DOCUMENT 00 90 01 - ADDENDA

- A. Project Name: CAPITAL PROJECT PHASE 4.
- B. Owner: OWEGO APALACHIN CENTRAL SCHOOL DISTRICT.
- C. Architect: HIGHLAND ASSOCIATES.
- D. Construction Manager: TAMCO LLC
- E. Architect Project Number: 2024-240P.
- F. Date of Addendum: APRIL 30, 2026.

1.4 CLARIFICATIONS AND RFIs

EXISTING ROOF FRAMING PLAN - PARTIAL PART A

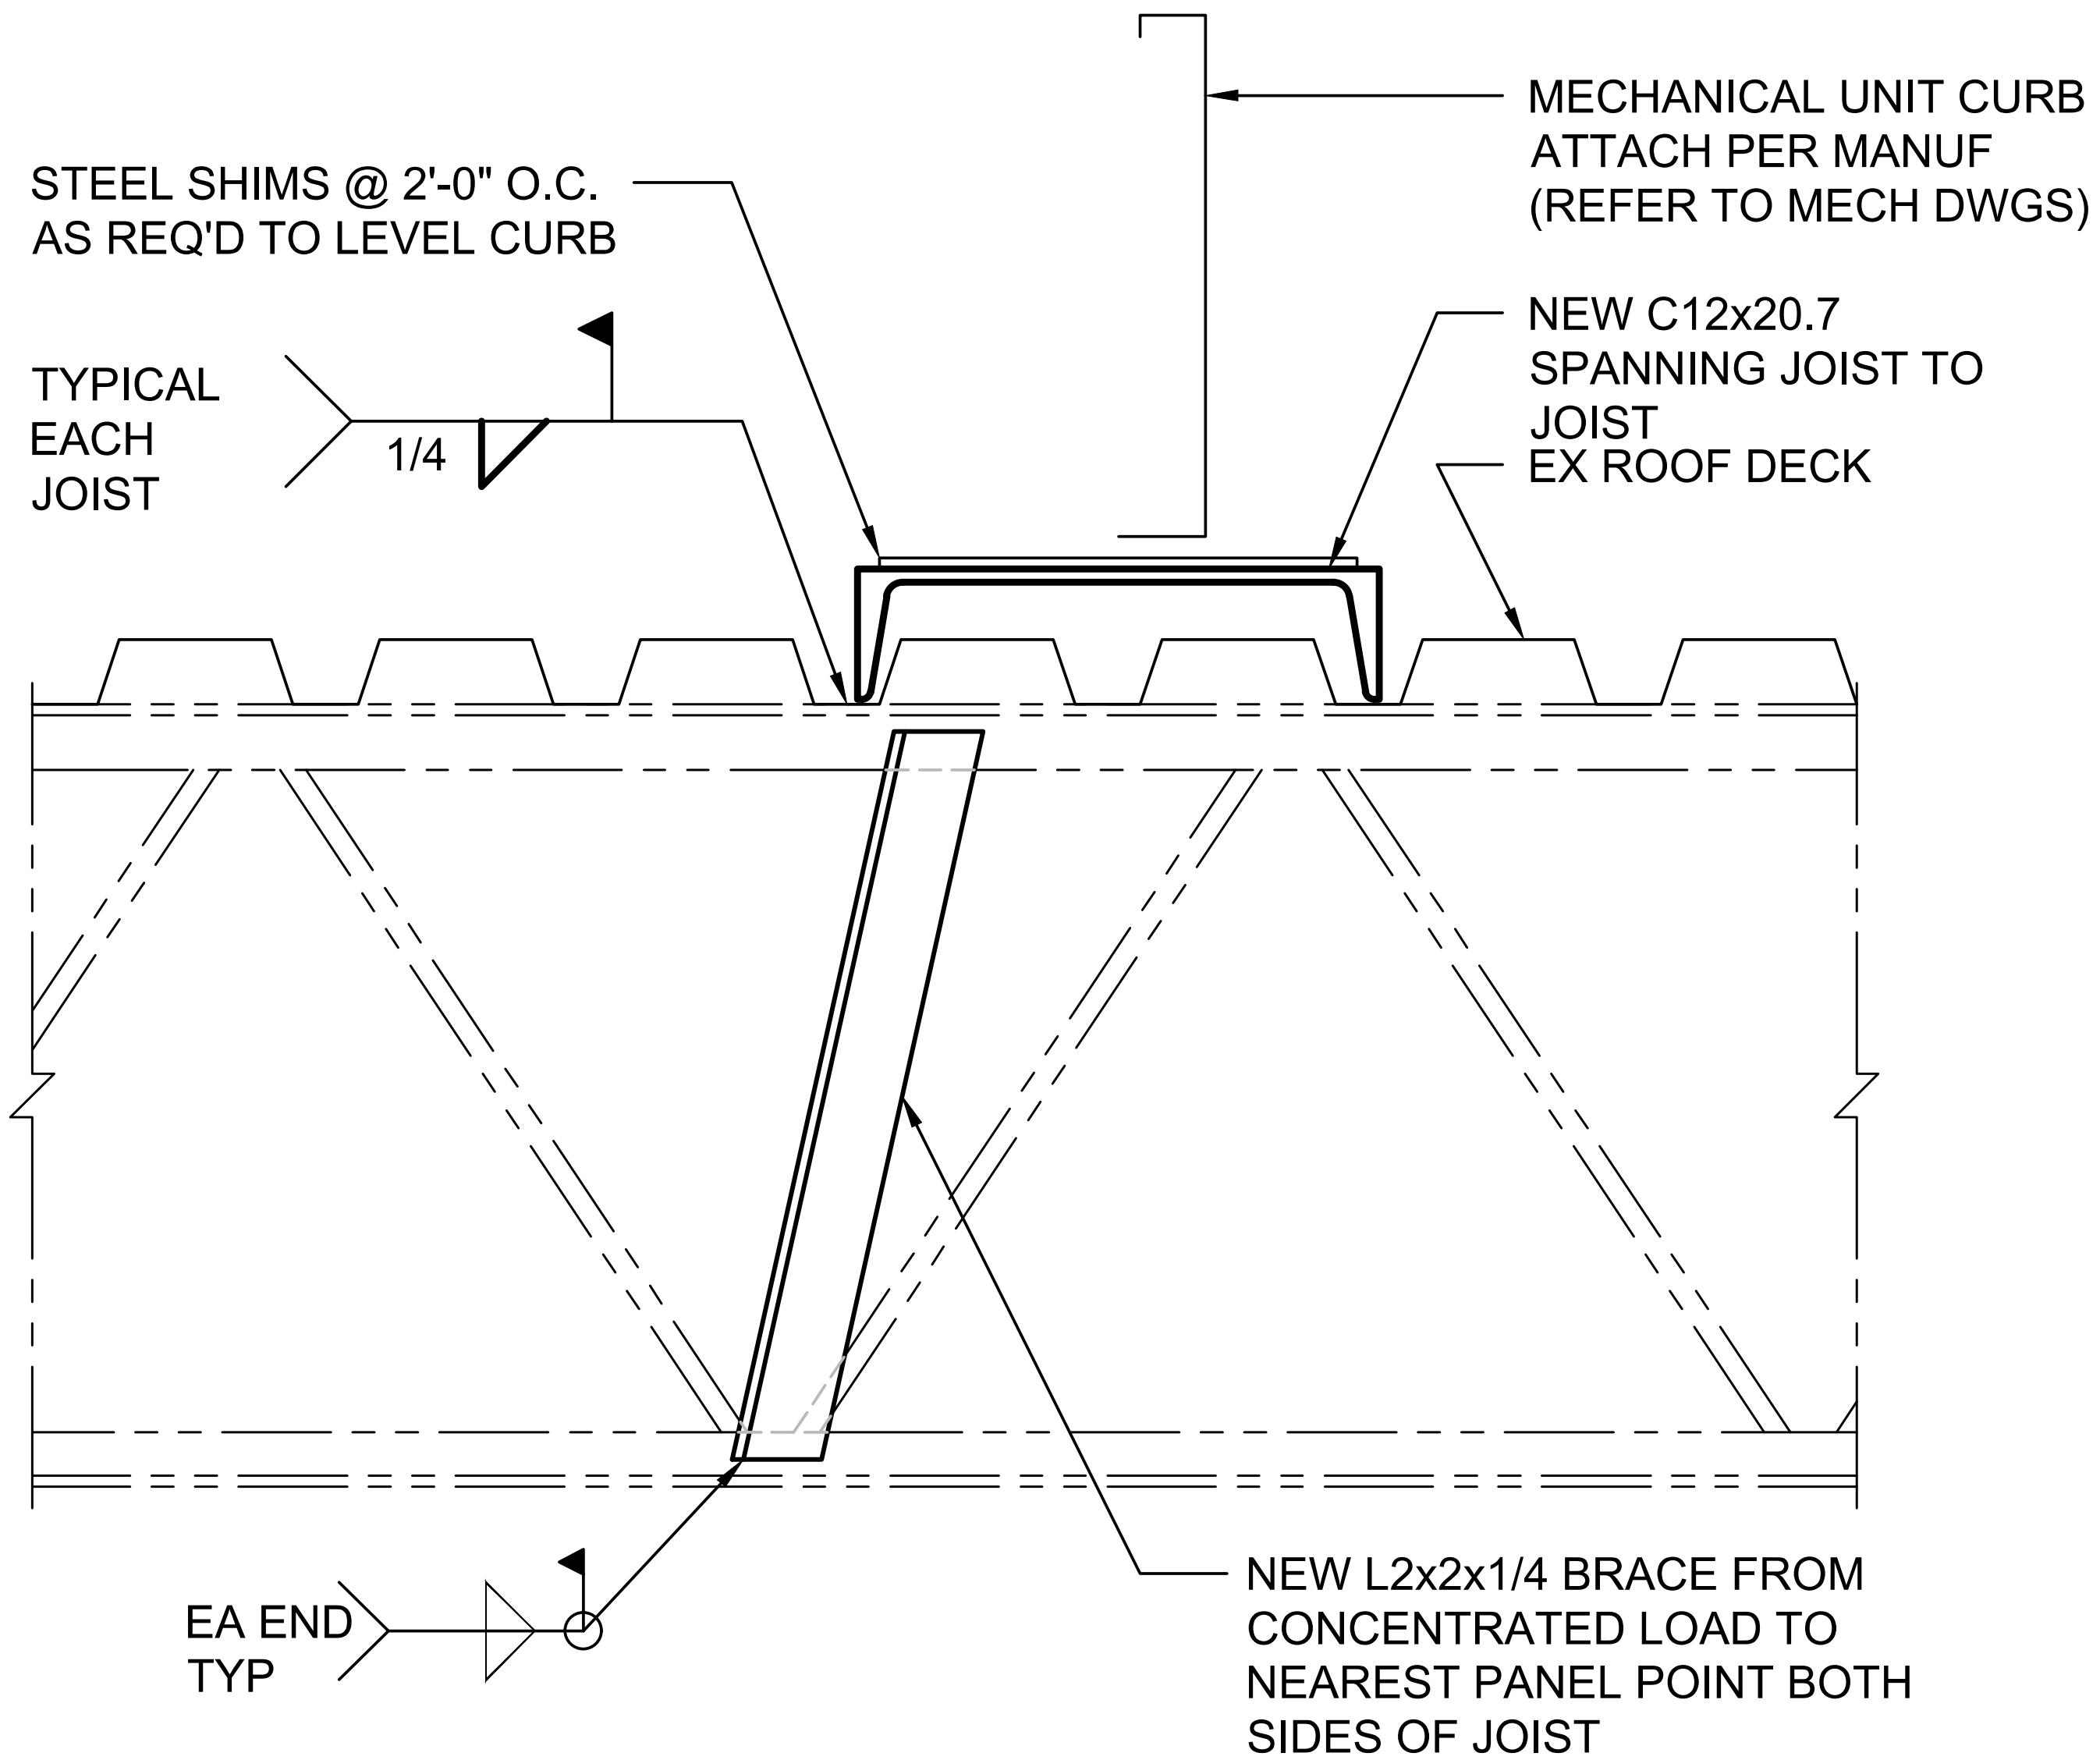
REQUEST: Is the Dehumidifier to be Mounted on
a Roof curb.
Note on S-102 Says See Detail on S-103.
There is NO curb Detail shown on S-103

ANSWER: - **MC SHALL PROVIDE PDU-1 WITH 18" HIGH INSULATED ROOF CURB PER REMARK #7 ON PDU-1 SCHEDULE ON DRAWING OFA M-601.**

- **MC SHALL PROVIDE CU-PDU-1 WITH (3) PATE MODEL ES-2 ROOF SUPPORTS, EACH PERPENDICULAR TO THE TWO C12x20.7 CHANNELS SHOWN ON THE S DRAWINGS. SEE ATTACHED SKETCHES.**

GATE ELEVATION - LATCH POST DETAIL

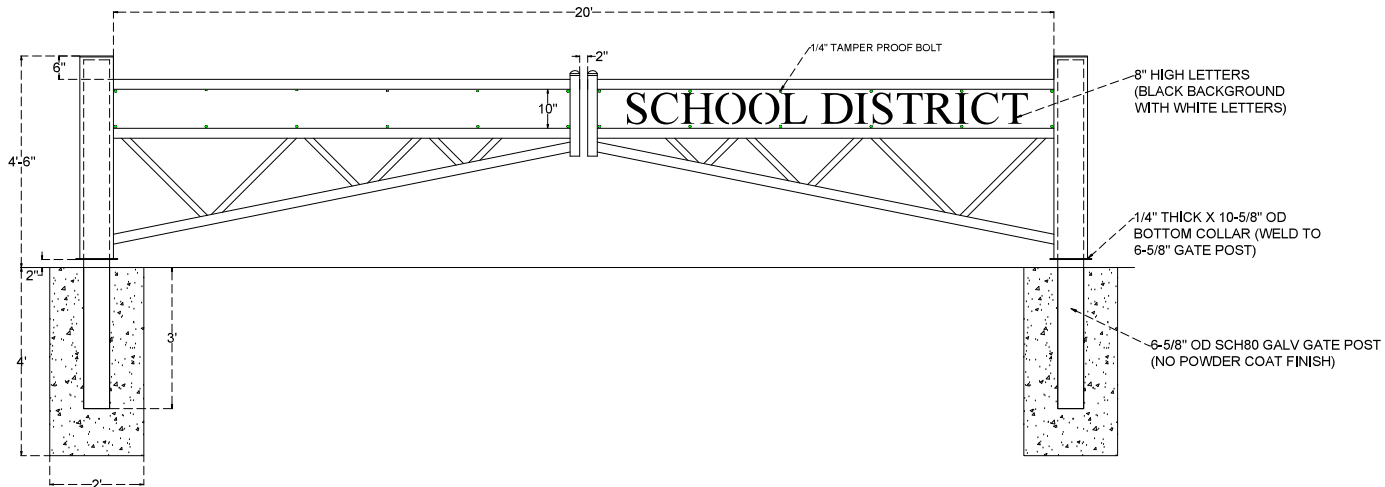
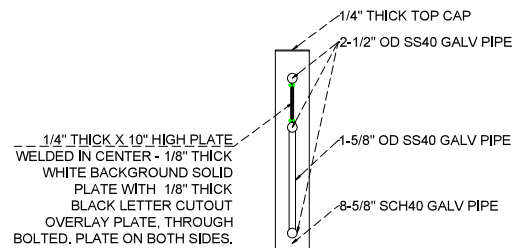
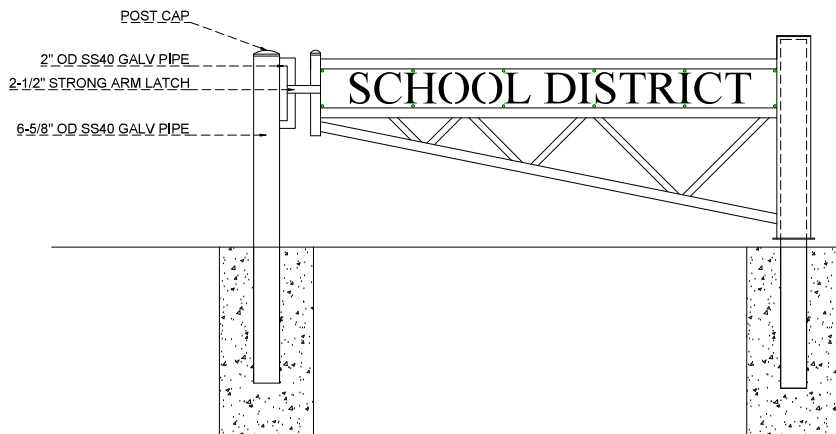
I wanted to know what the latch detail was for this gate.
I also had a question about the posts. On the left post, it states a 6" bollard and cap, on the right post it has a 7" post in the ground with an 8" post over the top of it that is part of the gate. Is that 6" bollard correct?
